Addendum #3

Date: September 16, 2016

PROJECT #: HU-0027-B01
Harrison New Elementary School
Harrison Public Schools

DESCRIPTION: Addendum #3

POST-ESP
ANTICIPATED
CONDITIONS
PLAN

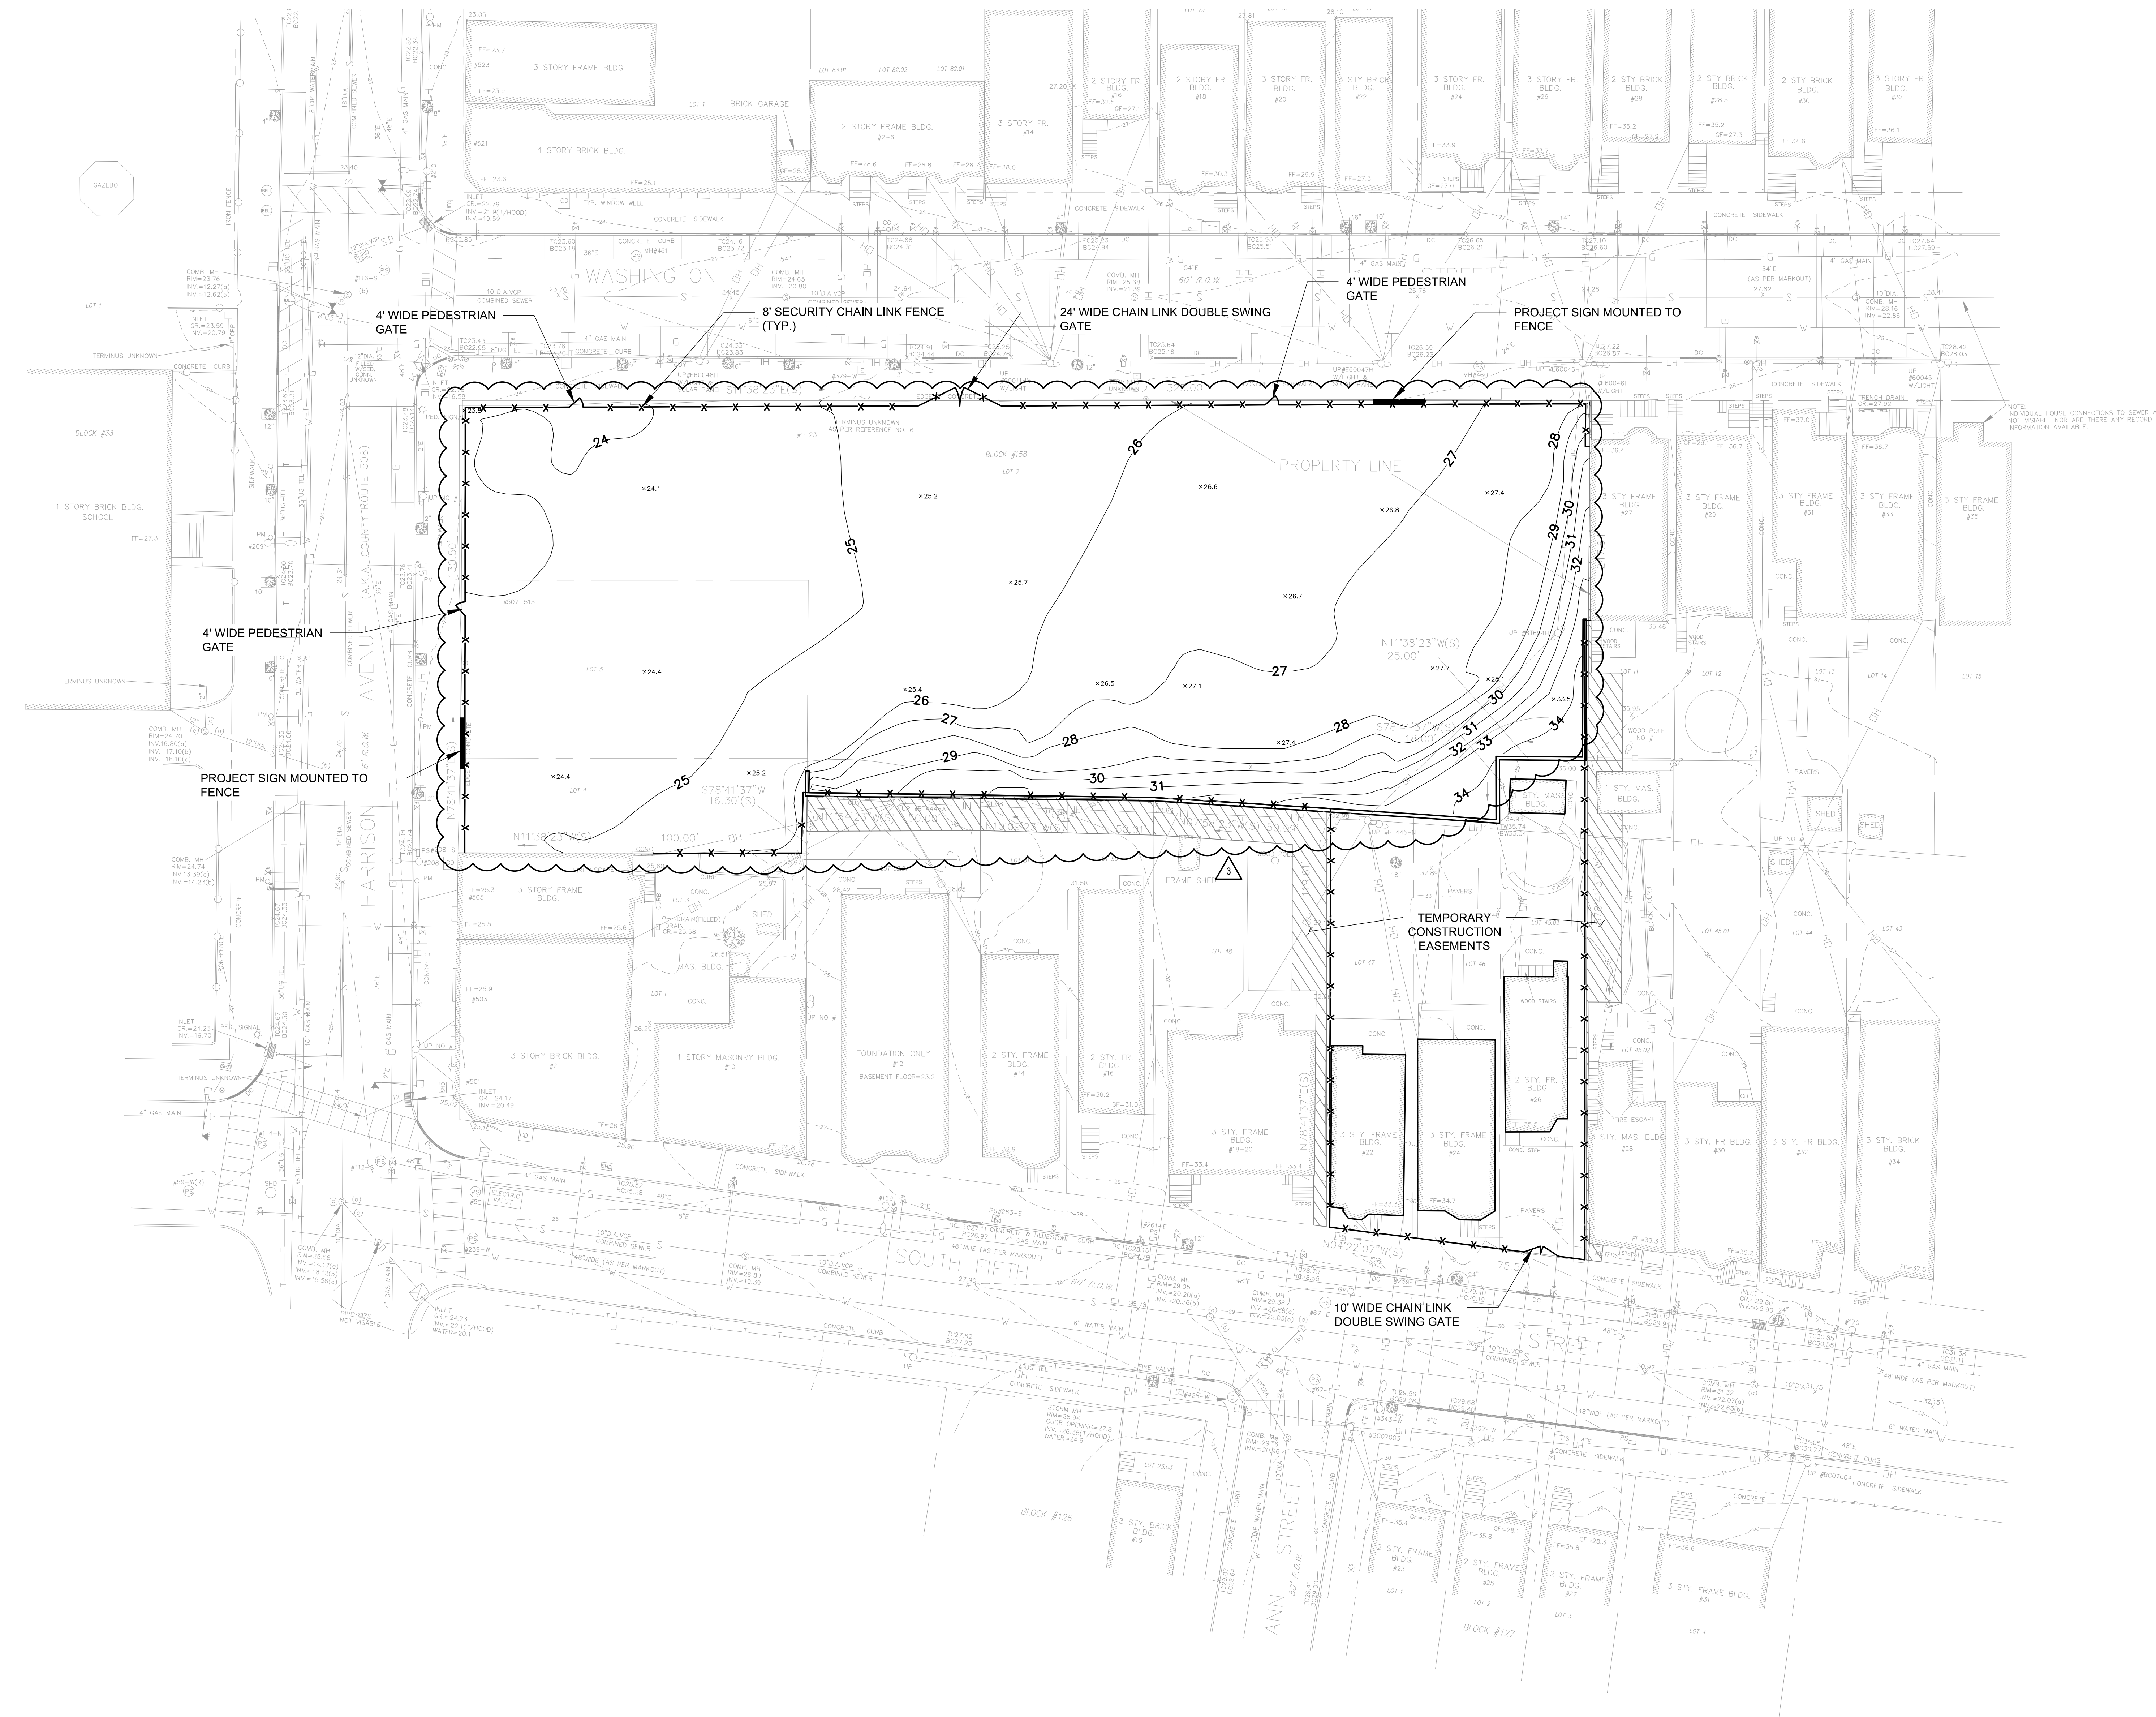
1. REPLACE: Replace Drawing C-104 - POST-ESP CONDITIONS PLAN, dated 07/07/2016, with Drawing C-104 - POST-ESP ANTICIPATED CONDITIONS PLAN dated September 9, 2016, included herewith as Attachment 3.4. All other plans, sections and elevations are modified accordingly by implication.
